UNITED STATES PATENT AND TRADEMARK OFFICE

APPLICATION NO.	FILING DATE	FIRST NAMED INVENTOR	ATTORNEY DOCKET NO.	CONFIRMATION NO.
09/635,549	08/10/2000	Yevgeniy Eugene Shleyn	US000209	7153

Office Action Summary

09/635,549

FIG. 3

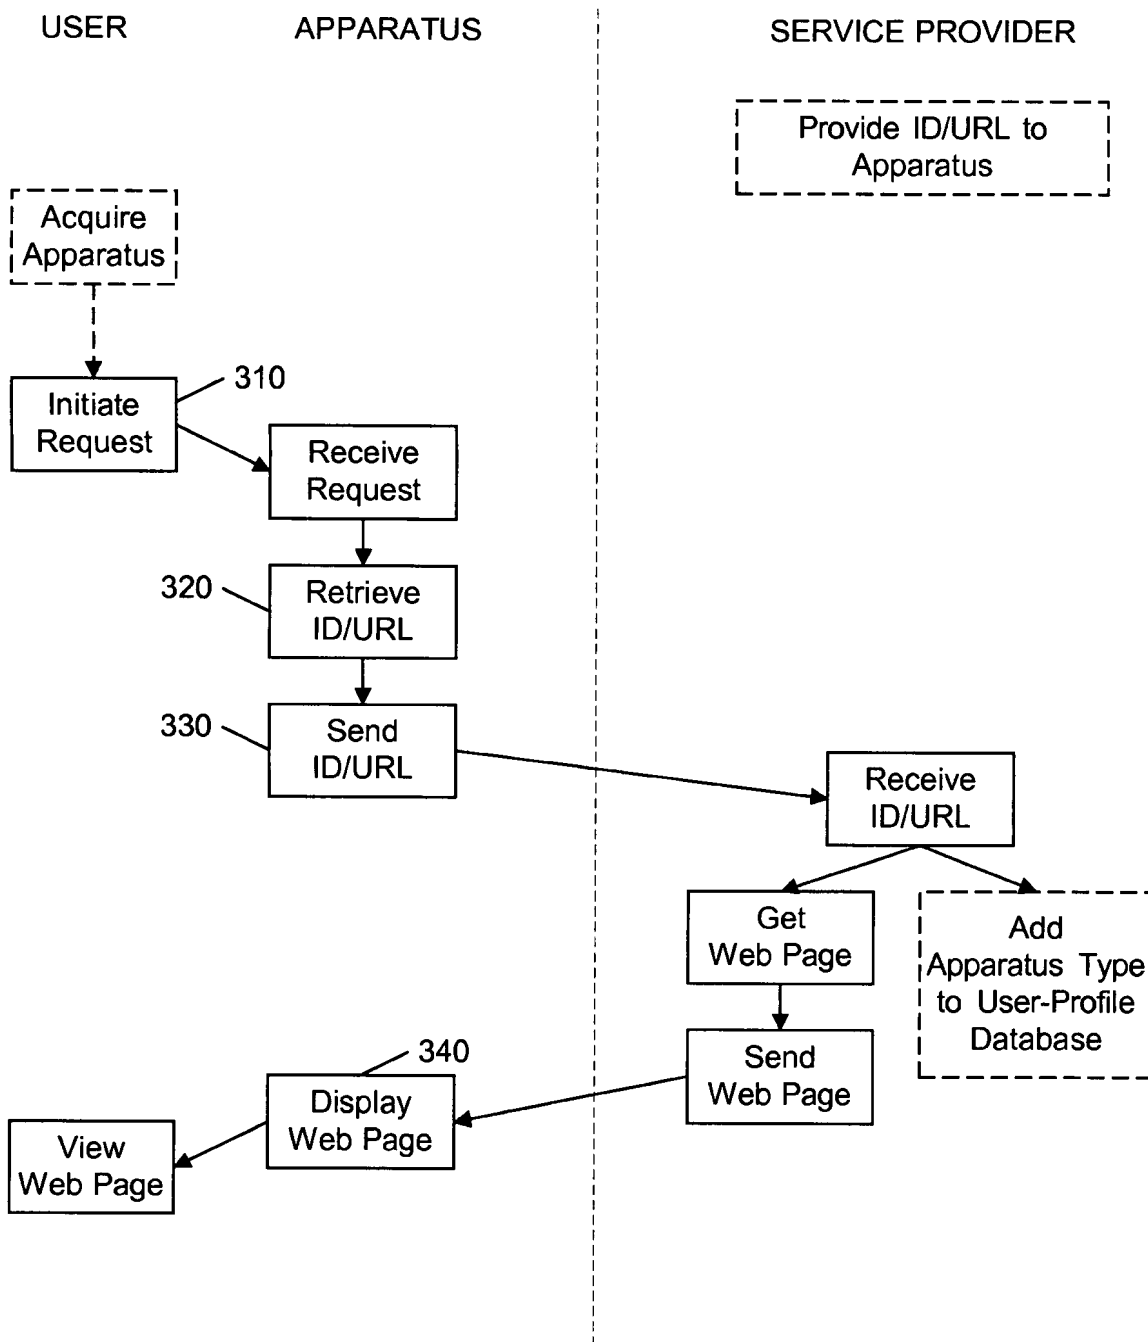
indicated by a specific URL”) in the original specification that teaches the use of URL to retrieve the content data from the remote server. What kind of a proxy device 202 that can perform such function? Moreover, there is no teaching in the original application as amended drawing (4/4/07), especially the newly added figure 3 which contains a new matter and it will not be entered. The newly added specification does not sufficiently describe this newly added figure either. Applicant is reminded that each elements or items of drawing must be labeled and sufficiently described in detail. And, the applicant is suggested to cite where in the specification that teaches the newly added features of figures 1-3.

Do not
enter
7/1/07
K

new matter
